ADDENDUM NO.5

PROJECT - ECA @ CEC Modernization, Renovation & Addition

RFP NO. 21-032 RRR
APS PROJECT # 507
NIGP Code: 90927; 90928; 909

A1 REFLECTED CEILING PLAN - LEVEL 1

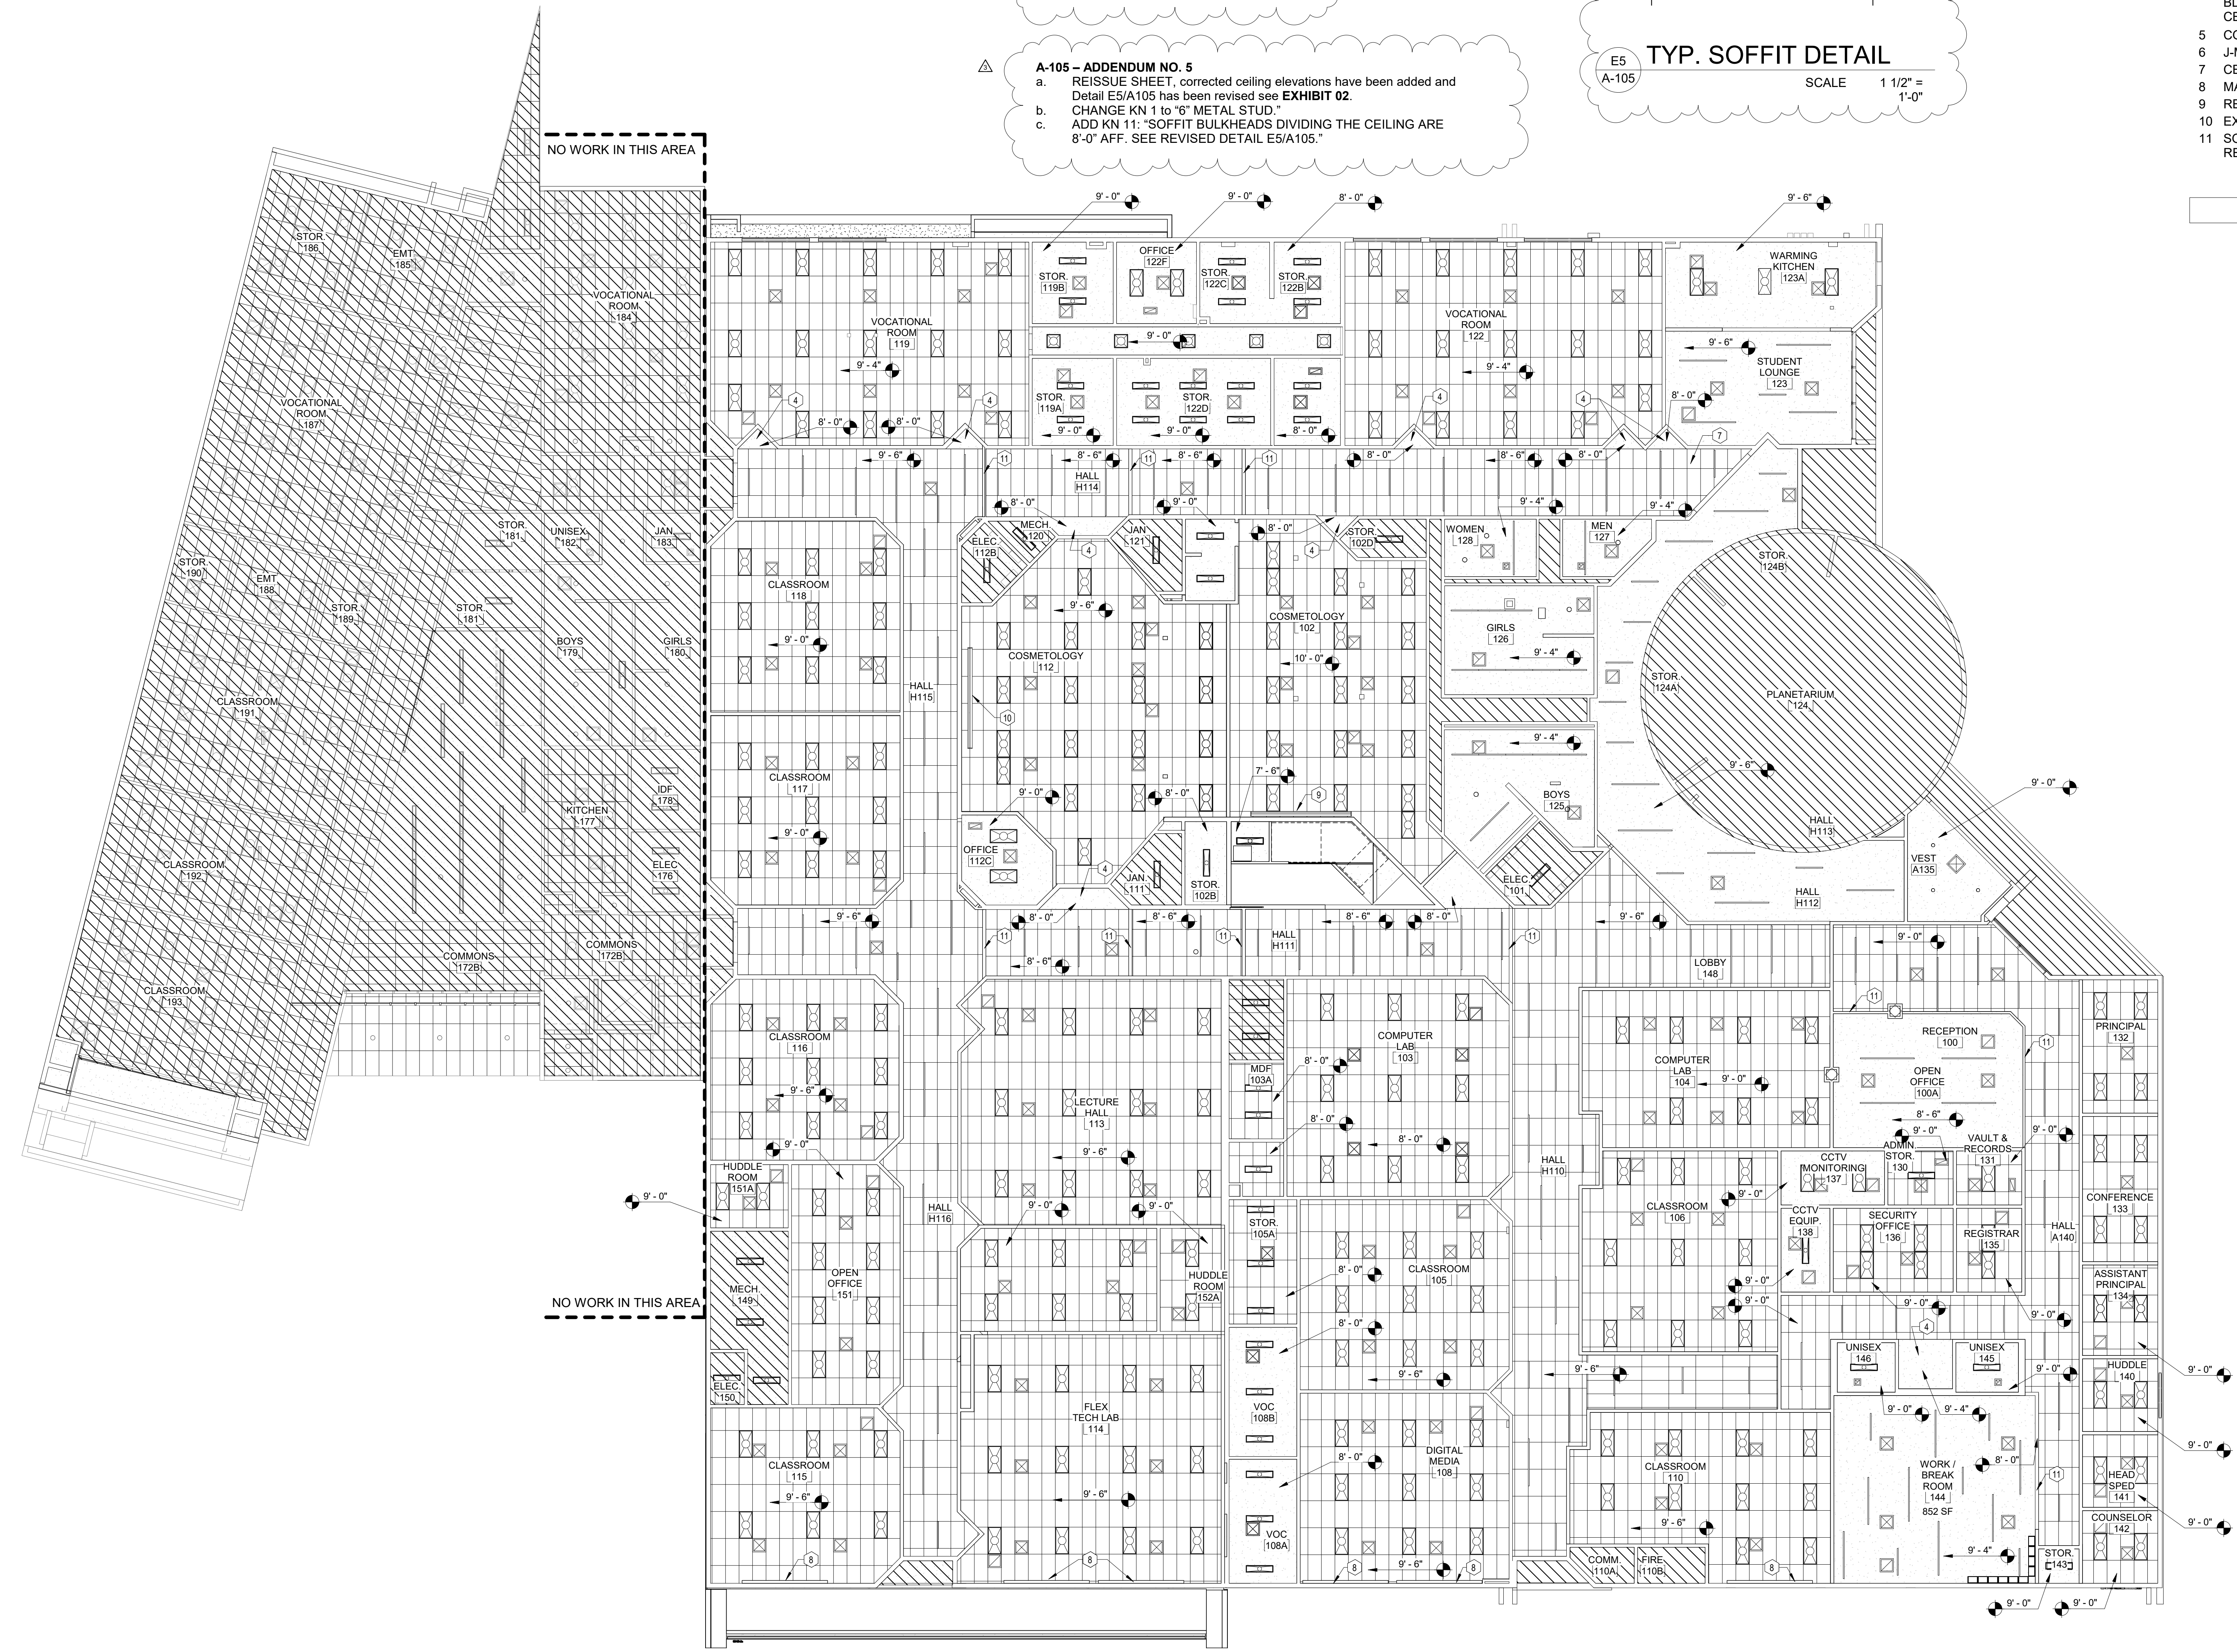
- a. REISSUE SHEET, corrected ceiling elevations have been added and Detail E5/A105 has been revised see **EXHIBIT 02**.
- b. CHANGE KN 1 to "6" METAL STUD."
- c. ADD KN 11: "SOFFIT BULKHEADS DIVIDING THE CEILING ARE 8'-0" AFF. SEE REVISED DETAIL E5/A105."

- A-105 - ADDENDUM NO. 5**
- a. REISSUE SHEET, corrected ceiling elevations have been added and Detail E5/A105 has been revised see EXHIBIT 02.
 - b. CHANGE KN 1 to 6" METAL STUD.
 - c. ADD KN 11 "SOFFIT BULKHEADS DIVIDING THE CEILING ARE 8'-0" AFF. SEE REVISED DETAIL E5/A105."

ROOF DECK 235 SKETCH

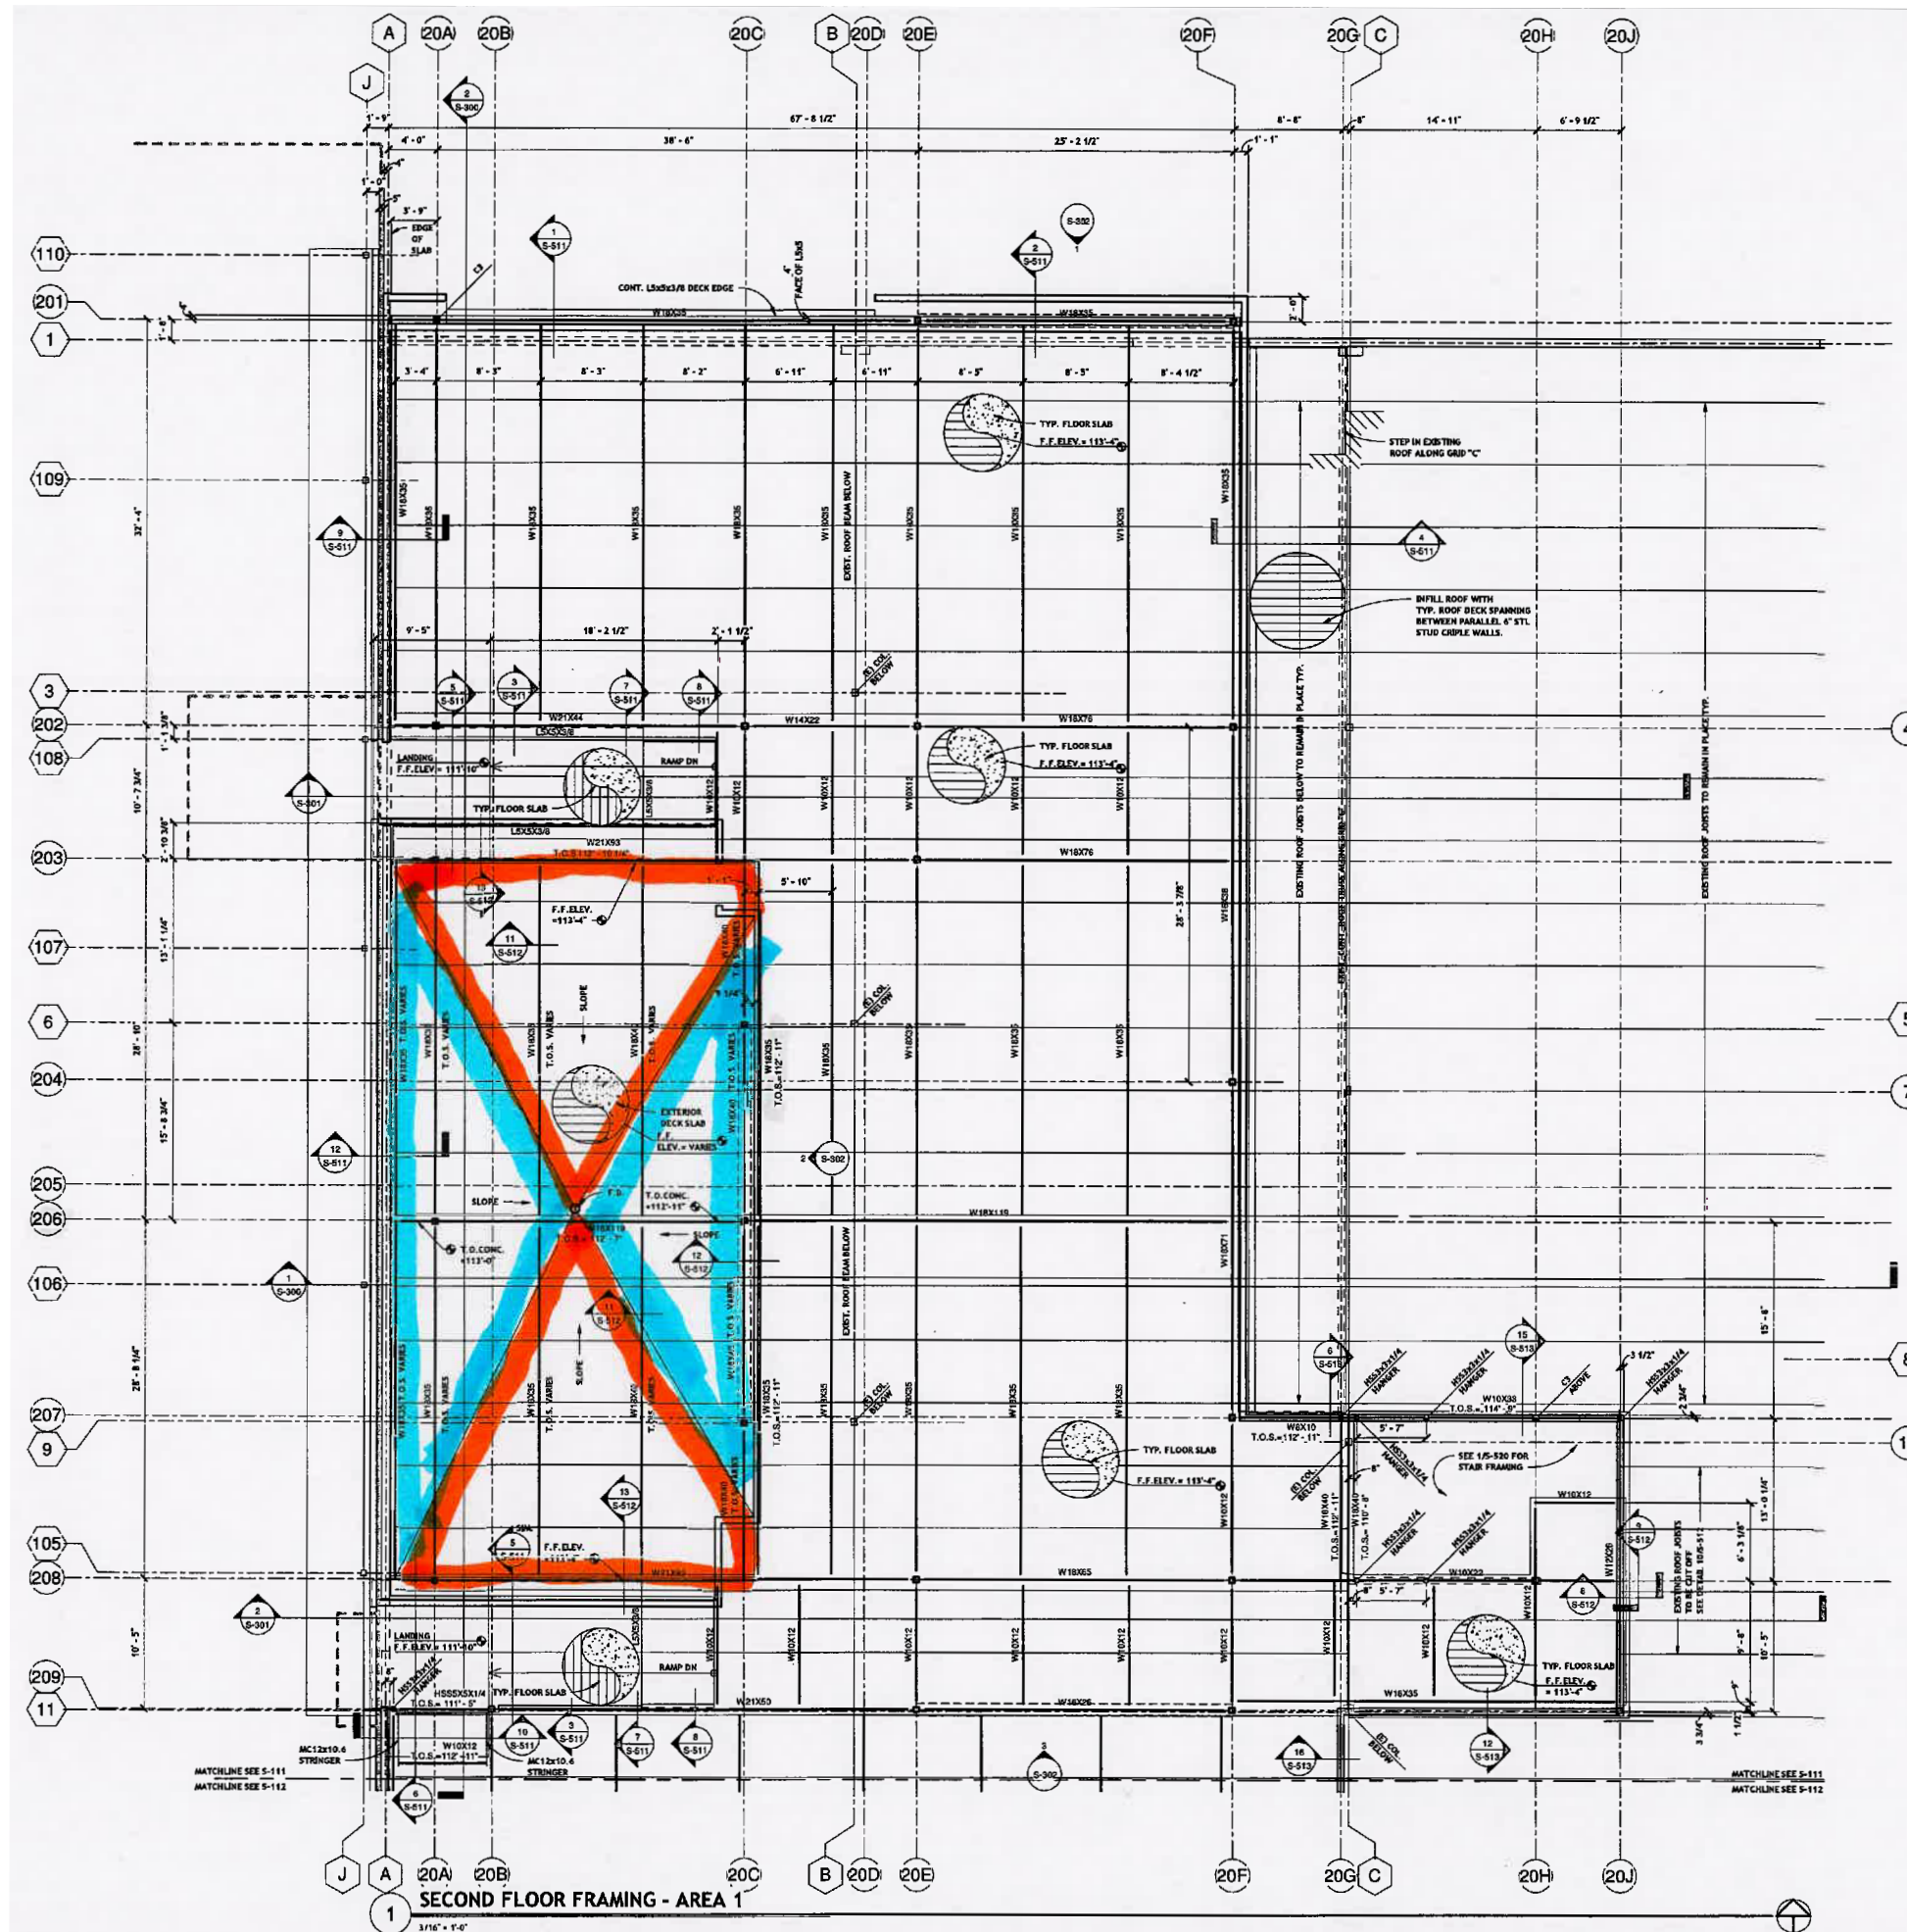
- a. **Clarification regarding ROOF DECK 235 Inconsistencies between Structural Details 11/S-512 + 12/S-512 and Architectural Detail E3/A-503.**

-
- b. Detail 12/S-512 may not reflect this clearly, because the dimensions called out are at grid line 206. The lowest point. The 5" dimension is from finished floor to top of steel. The 4" dimension below that is from top of steel to top of concrete slab over the exterior deck, but that is a max. dimension and will vary as the slab slopes up to grids 203 and 208.

Detail E3/A-503 shows 5" between FF elevations. That is what we have along grids 203 and 208, but along grids A and 20C the Deck slab slopes down making it more than 5". However, from the second floor FF slab to the top of the tapered rigid insulation is 5". The Rigid insulation will be 4" thick at grid 206 and taper to 0 at grids 203 and 208. It will also be 0 at the drain.
